# Technical Document LA24032

Application under the Agricultural Operation Practices Act for a confined feeding operation, manure collection area, and/or manure storage facility(ies)

<b>NRCB USE ONLY</b>	Application number <b>LA24032</b>	Legal land description <b>SW 32-8-24 W4M</b>
<input checked="" type="checkbox"/> Approval <input type="checkbox"/> Registration <input type="checkbox"/> Authorization <input type="checkbox"/> Amendment

# Catch Basin Storage Volume Calculator

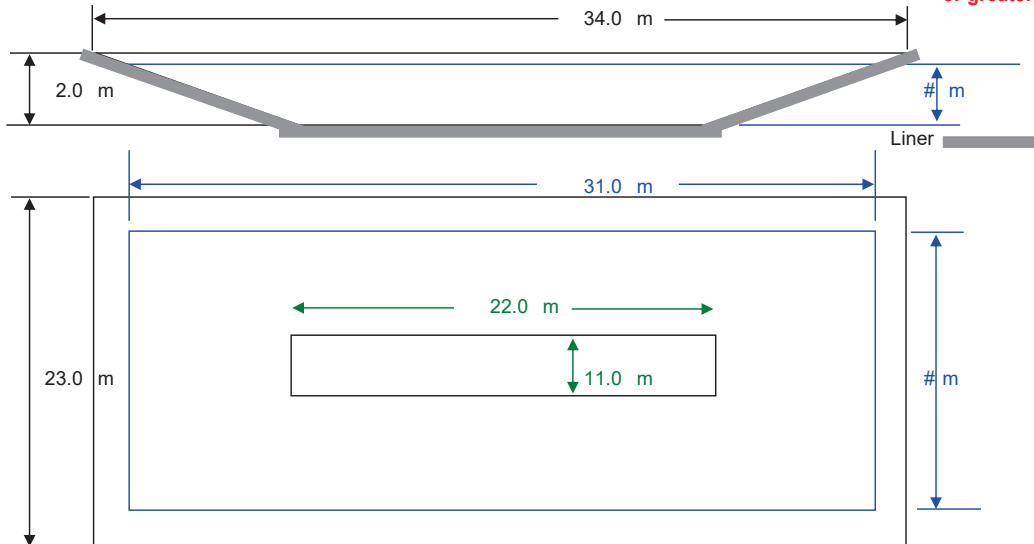
AO Comment: Initial proposed dimensions of new catch basin did not meet AOPA 9 month storage requirements for run-off. Applicant has proposed new dimensions to meet AOPA requirements.

Catch basin calculator. Total volume @ freeboard level: 626 m<sup>3</sup> Runoff capacity requirements met:  YES  NO

Figure 1: Site Layout & Borehole Locations

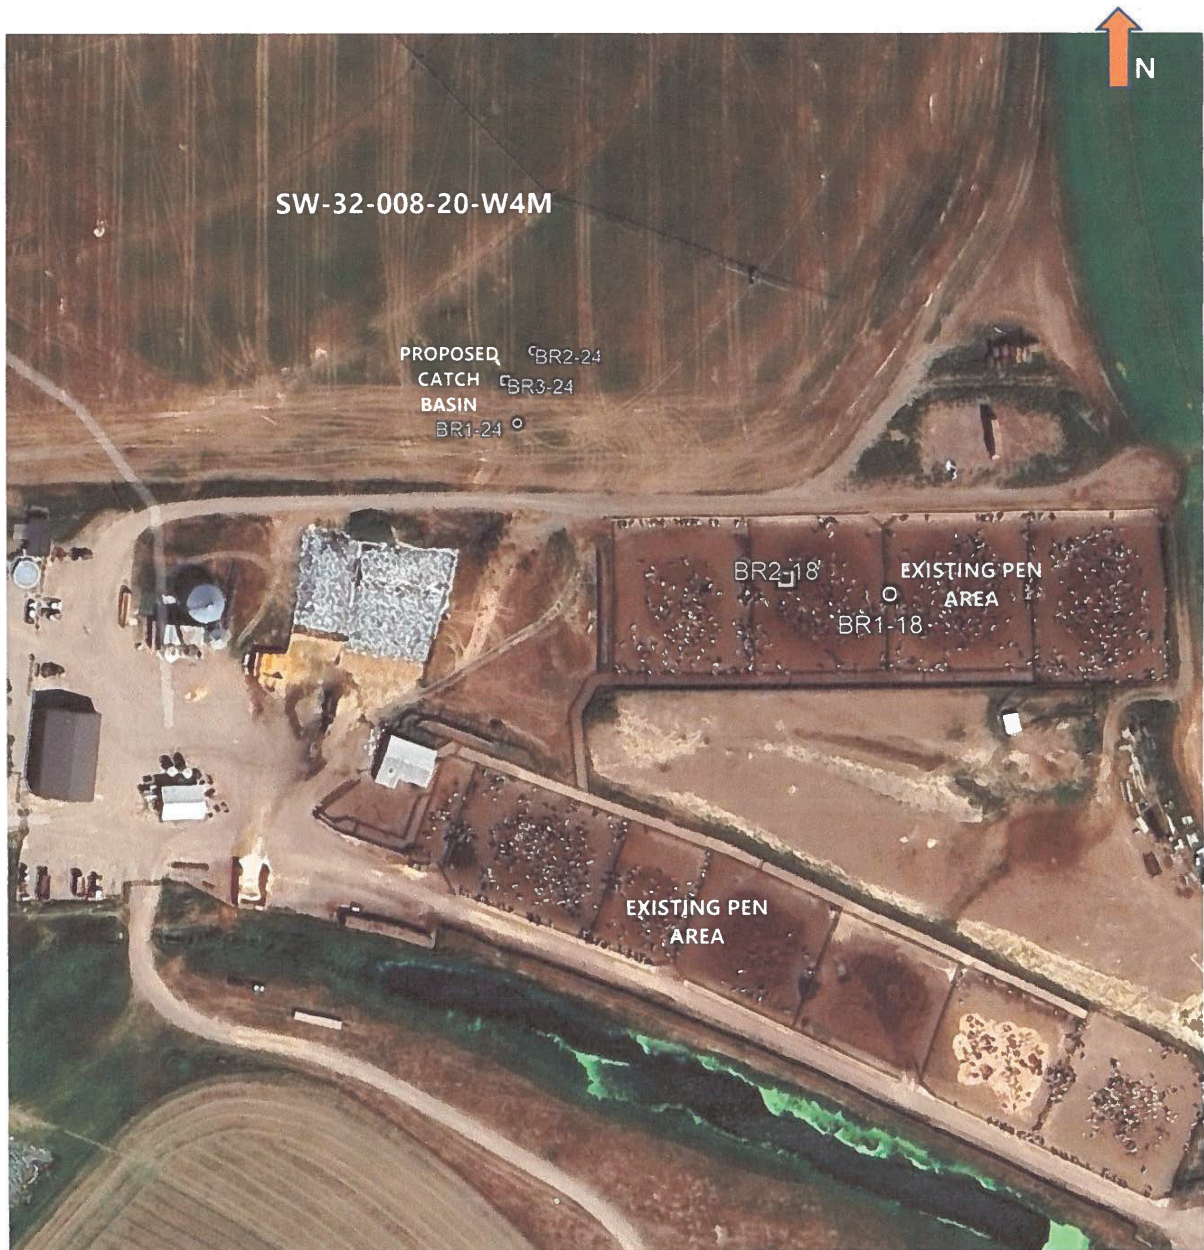
AO Comment: Using the equivalency equation for single layer systems as outlined in Technical Guideline Agdex 096-61 "Determining Equivalent Protective Layers and Constructed Liners", the proposed 0.9 m thick naturally occurring protective layer with hydraulic conductivity of  $1.2 \times 10^{-7}$  cm/s, is equivalent to 7.5 m of naturally occurring protective material with a hydraulic conductivity of  $1 \times 10^{-6}$  cm/s. This exceeds the minimum 5 m of naturally occurring protective material as required by AOPA.
